CITY OF TEMPE DEVELOPMENT REVIEW COMMISSION

Meeting Date: 11/27/2018 Agenda Item:

<u>ACTION</u>: Request a Zoning Map Amendment, Planned Area Development and Development Plan Review for a singlefamily residential development consisting of 80 two-story attached units for THE LEVEL, located at 915 South Smith Road. The applicant is Earl, Curley & Lagarde.

DEVELOPMENT PROJECT FILE for THE LEVEL (PL180235)

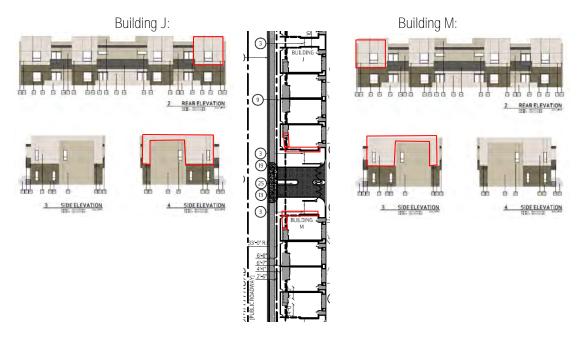
- 15. Building A, at the south east corner of University Drive and Smith Road, shall have the masonry brick extended to the second floor on the north and west elevations as viewed from public streets.

2 BUILDING J WEST ELEVATION BUILDING M WEST ELEVATION

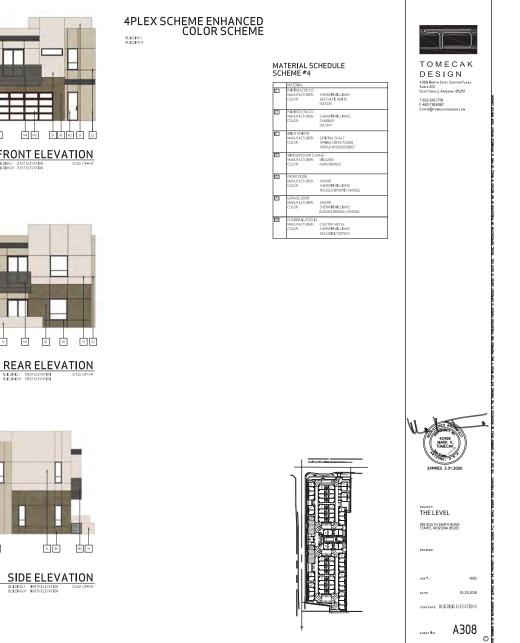
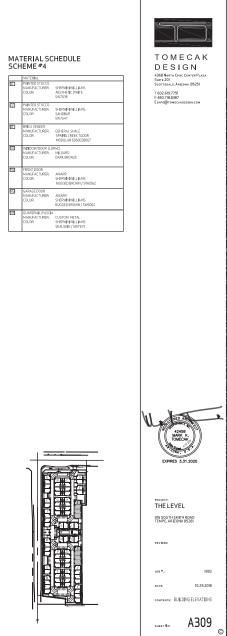
16. Buildings J and M, at the development entrance on Smith Road, shall have masonry brick extended to the second floor on the west, south and north elevations of the two end units adjacent to the driveway entrance.
